## STAFF RECOMMENDATION 1200 Fatherland Street October 16, 2019

**Application:** New Construction—Addition; Setback Determination  
**District:** Lockeland Springs-East End Neighborhood Conservation Zoning Overlay  
**Council District:** 06  
**Base Zoning:** R6  
**Map and Parcel Number:** 08313010400  
**Applicant:** Cheyenne Smith  
**Project Lead:** Melissa Sajid, [melissa.sajid@nashville.gov](mailto:melissa.sajid@nashville.gov)

**Description of Project:** Application is to construct a rear addition and includes a setback determination to reduce the rear setback from twenty feet (20') to nineteen feet (19').

Figure 1. 1200 Fatherland Street

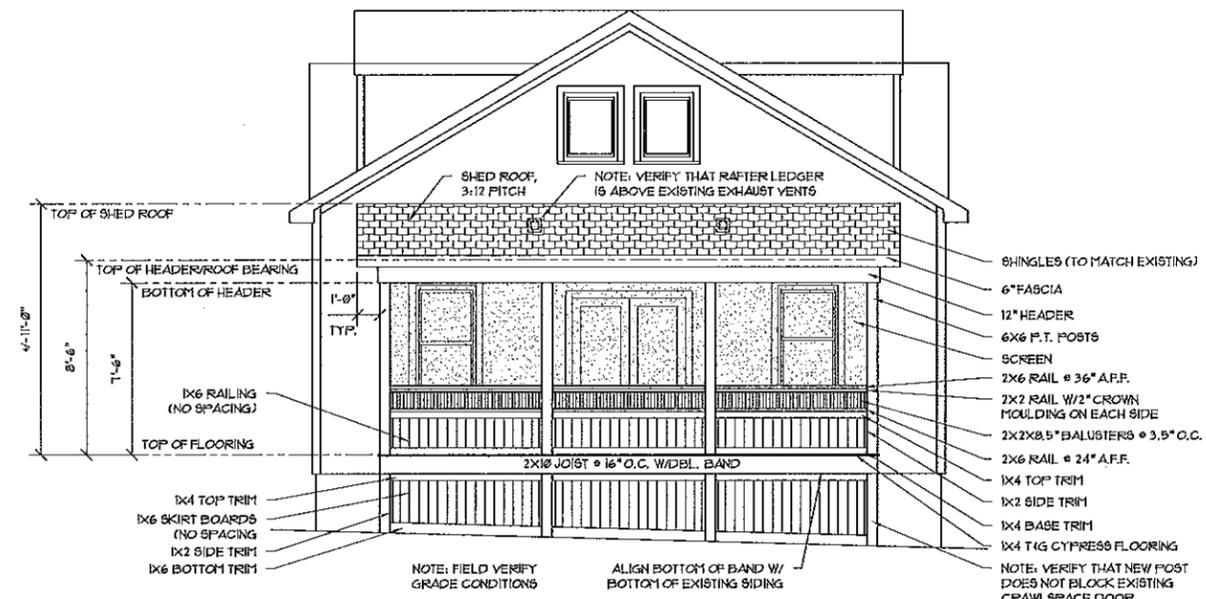
**Background:** The house located at 1200 Fatherland Street was constructed c. 1955 and does not contribute to the historic character of the Lockeland Springs-East End neighborhood due to the date of construction relative to the development of the neighborhood (Figure 1). An administrative permit was issued in 2015 for a ridge raise and rear addition.

04 REAR ELEVATION (SOUTH)

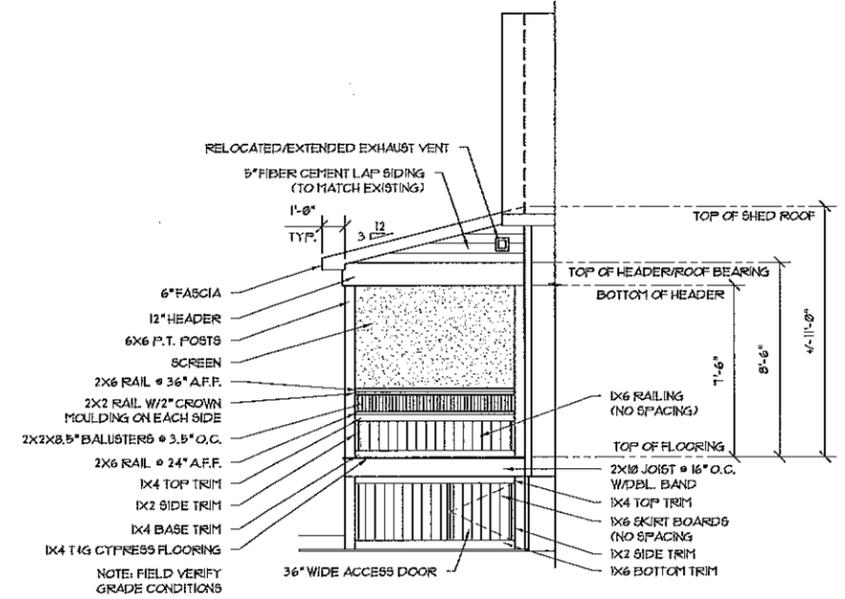
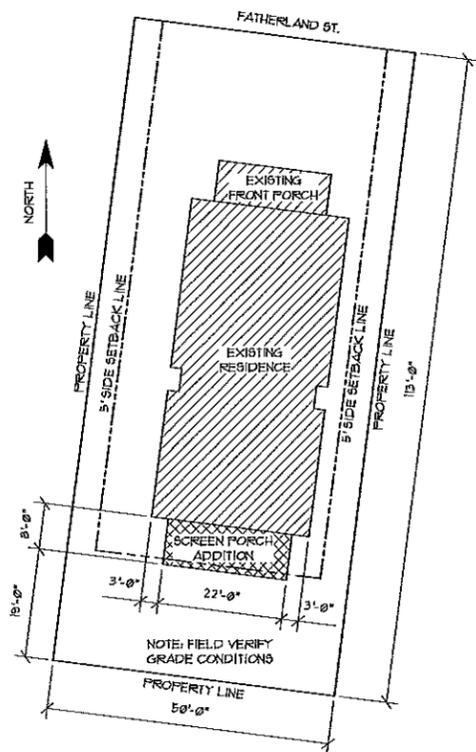
Height & Scale: The proposed addition is located at the rear and is single-story. The addition has a footprint of one hundred seventy-six square feet (176 sq. ft.) while the existing house has a footprint of approximately one thousand, six hundred ninety-six square feet (1,696 sq. ft.). As proposed the addition does not extend taller or wider than the existing house.

Design, Location & Removability: The proposed addition is located at the rear. The screened porch is single-story with a shed roof form, which is common of this type of addition. Since the house is not historic, the concerns about the addition's removability and distinguishing the addition from the original house do not apply.

Roof form: The screened porch will have a shed roof form with a pitch of 3/12, which is appropriate for a single-story screened porch addition.

01 SITE PLAN

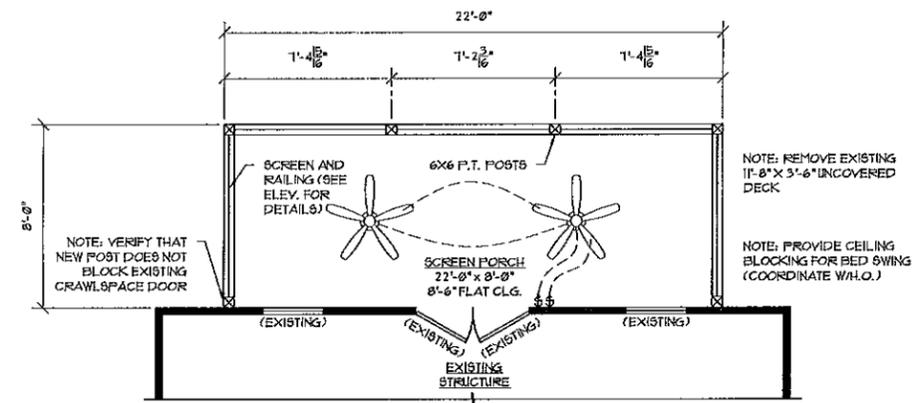
Setback & Rhythm of Spacing: The screened porch addition meets the base zoning requirements for the side setbacks but not the rear setback. As proposed, the addition

will be approximately twelve feet (12') from the left-side property line, seventeen feet (17') from the right-side property line, and nineteen feet (19') from the rear.

The applicant has requested a setback determination to reduce the rear setback from twenty feet (20') to nineteen feet (19'). Staff finds that a rear setback determination could be appropriate in this case for several reasons given the depth of the lot and modest size of the addition. The lot is somewhat shallow at one hundred thirteen feet (113') deep, and the proposed addition is for a screened porch that is only eight feet (8') deep. For these reasons, staff recommends approval of the rear setback determination.
